SERVICE BULLETIN

Number: SB16-0018

Title: Software Enhancement Single
Stage Control Boards

Product Category : 35" Tall Condensing Gas Furnaces

Example of Single Stage Control Board	Example of Barcode, Software Version, vendor Number & Date Code
	<p>In this example: The software version is 04 The part number is 1186115 vendor # HK42FZ061 Produced in week 40 of 2016 Note: See Table 1 for production date codes</p>

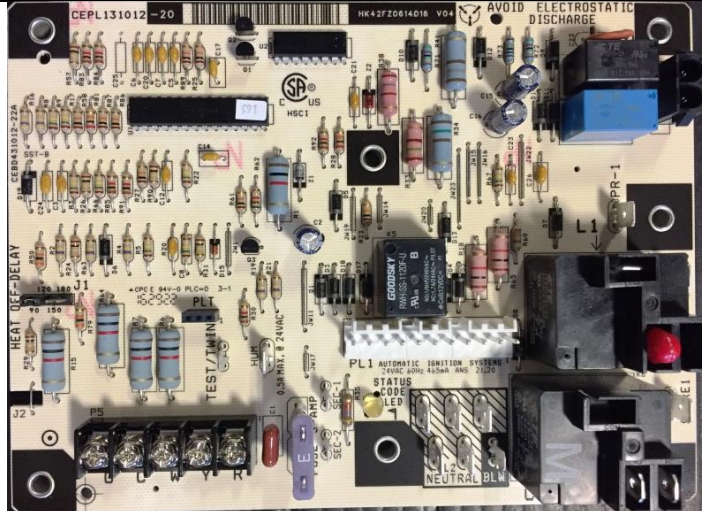
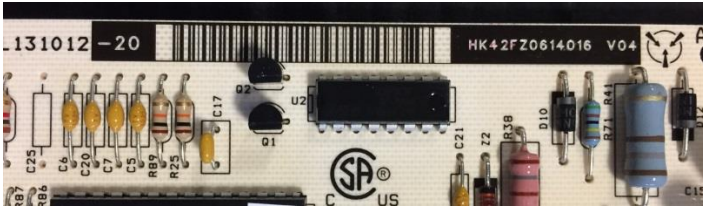
All condensing single stage furnaces are now being produced with a software version label. The single stage furnace control boards can be identified by a software version label, for example, V04 on the control board after the barcode and vendor part number:
